MTV PERIPHERAL – Change log

Date	3 August 2021
Part revision	7
Document revision	1
Author	Aalap Patel

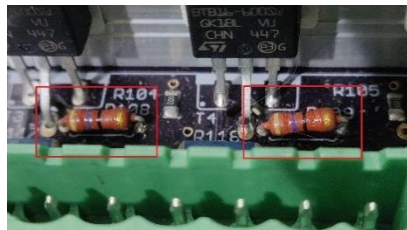
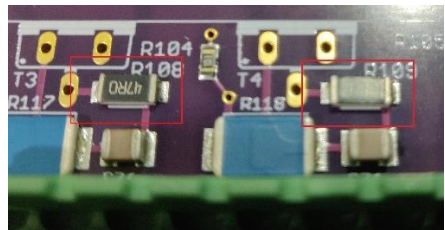
Modification Instructions	Rev 6	Rev 7
<ul style="list-style-type: none"> Replaced R108 to R113 from through hole to SMT 47Ω. 		
<ul style="list-style-type: none"> Replaced J2(MCU link) from 16 pos. connector male to 10 pos. connector male.

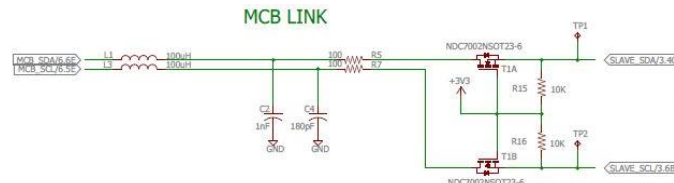
<ul style="list-style-type: none"> MCB LINK part is removed in Rev-7. 		
<ul style="list-style-type: none"> Firmware updates minor.
